UNITED STATES PATENT AND TRADEMARK OFFICE

APPLICATION NO.	FILING DATE	FIRST NAMED INVENTOR	ATTORNEY DOCKET NO.	CONFIRMATION NO.
10/764,105	01/23/2004	Cong Thanh Dinh	577-614	7912
23869	7590	11/04/2005	EXAMINER	
HOFFMANN & BARON, LLP 6900 JERICHO TURNPIKE SYOSSET, NY 11791			PATEL, DHIRUBHAI R	
			ART UNIT	PAPER NUMBER
			2831

Office Action Summary

1. Claims 6-12 are rejected under 35 U.S.C. § 102(b) as being anticipated by McNab (4,927,039).

Fig. 3

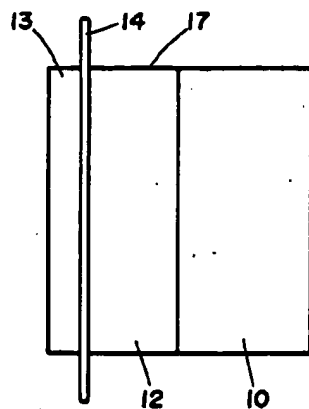
Regarding claim 8, a bracket (see sketch A) for attachment to an electrical outlet box 10 having a back wall, a side wall upstanding from and perimetrically bounding said back wall so as to define a box interior and an open face opposite said back wall (see figs 3-5, column 2 lines 65-68, column 3 lines 1-5), said bracket comprising: a generally planar flange 14 (see fig 5) positionable on an upper edge of said side wall (see fig 5) for spanning said open face of said box (see column 2 lines 38-68, column 3 lines 1-45), said planar flange having an opening therethrough (see fig 5) for accessing said box interior, said opening being bounded by a first extending wall 23 (see figs 3-5), said first extending wall extending a first distance and in a first direction from said planar flange and a second extending wall 12 extending a second distance and in a second direction from said planar flange (see fig 5, column 3 lines 1-5), said first distance being different from said second distance and said first direction being opposite said second direction (see figs 3-5, and column 3 lines 1-5).

Regarding claim 9, said first distance approximates the thickness of a first wall board and said second distance approximates the thickness of a second wall board of different thickness (see figs 3-5, column 3 lines 1-5).

Regarding claim 10, one of said first and second extending walls is positioned to extend into said box interior (see figs 3-5).

Fig. 5

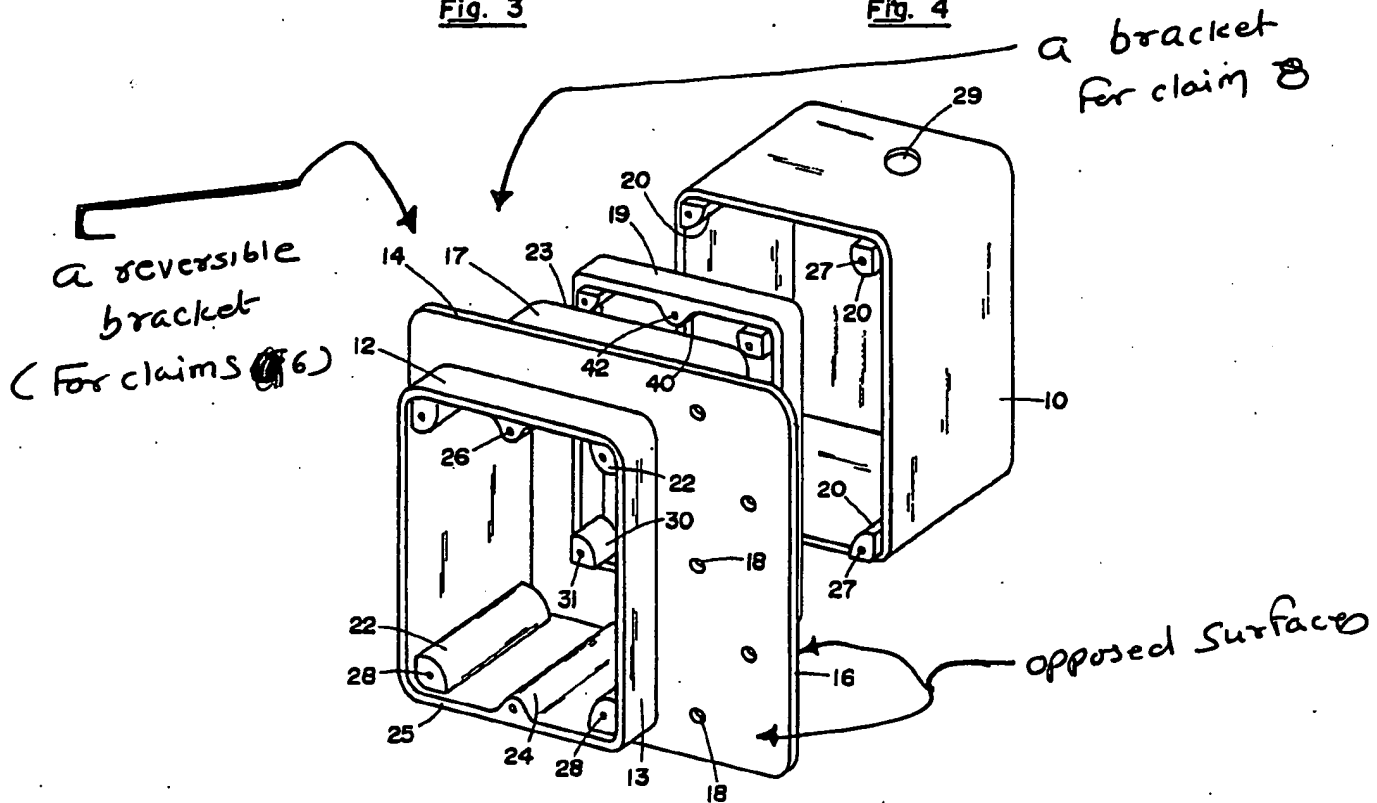
Regarding claims 6-7, reversible bracket (see sketch A) for attachment to an open front face of an outlet box 10 comprising (see fig 5): a planar flange 14 having opposed surfaces having a first position with one of said opposed surfaces being attachable to said open front face of said box (see figs 3-5, column 2 lines 65-68, column 3 lines 1-5 and sketch A) and a reversible second position with the other of said opposed surfaces being attachable to said open front face of said box (see figs 3-5, column 2 lines 65-68, column 3 lines 1-5 and sketch A); and a bounded access member 12 extending through said flange (see fig 5), said access member having an opening extending through said flange between opposite extending rims 23, 25 of said access member (see fig 5), one of said rims 23 being located a first distance from said open front face of said box when said flange is in said first position (see fig 5), and the other of said rims 25 being located at a second distance from said open front face of said box when said flange is in said reversible second position (see fig 5), and said first distance being

different from and said second distance (see fig 5). With respect to claim 7, It is noted that the assembly of McNab meet the structural limitations.

Regarding claims 11-12, a method of attaching an electrical outlet box, having a box interior and an open front face, to a stud (see column 3 lines 45-50) comprising the step of: providing a bracket (see sketch A) having a generally planar flange 14 and an opening therethrough (see fig 5), said opening being bounded by a first extending wall 23 (see fig 5) extending from said flange a first direction, and a second extending wall 12 extending from said flange a second distance in a second opposite direction (see fig 5), and first distance being different from said second distance (see fig 5, column 3 lines 1-5); attaching said bracket to said electrical outlet box over said open front face with one of said first or second extending walls extending into said box interior (see figs 3-4, column 2 lines 38-68); and attaching said box to said stud such that said other of said first or second extending wall extends outwardly from said face of said stud (see column 3 lines 45-50). With respect to claim 12, it is noted that the assembly of McNab meet the structural limitations.
